In the Drawings

REMARKS

FIG. 2

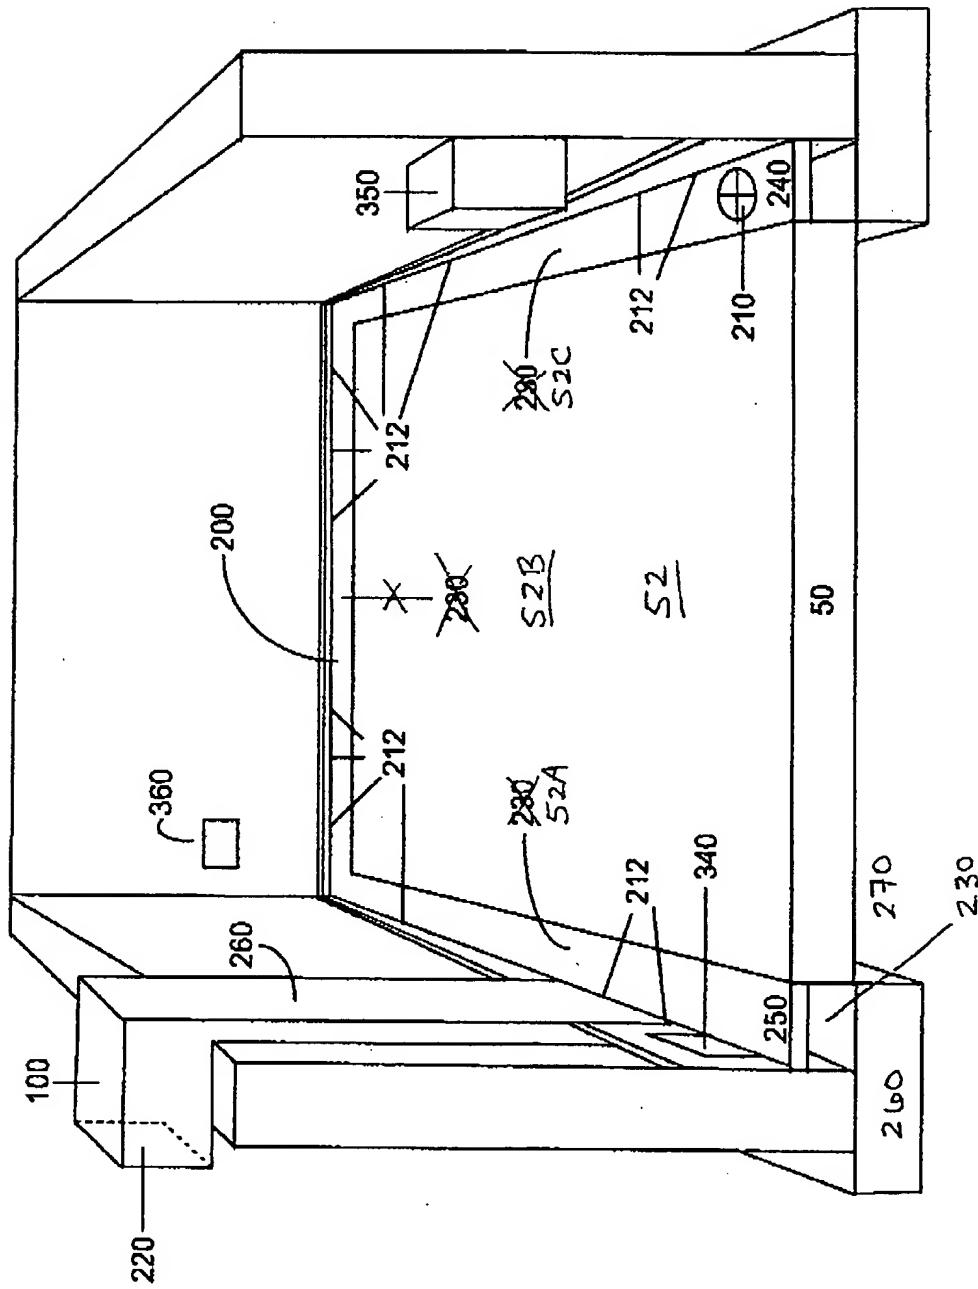
Applicant will subsequently be amending the specification to remove all references to A and B in the Figures. Accordingly, no changes to the drawings for these elements are necessary. Additionally, the Examiner noted that reference No. 330 in Fig. 2 should be 320, according to the specification. The Examiner also stated that the floor is not shown. Applicant respectfully submits that element 330 is correctly identified in Fig. 2. Element 330 is an air inlet which corresponds to air inlet 220 of Fig. 1. The outlet is a drain which leads to a gravity drain or a sump pump and is correctly identified as element 320 in Fig. 2. Fig. 1 has been amended to provide further clarification of the floor of the preferred embodiment, the foundation of a preferred embodiment and the location of the soil around the foundation in a crawl space in a preferred embodiment.

Replacement drawings showing these features are included with mark-ups.
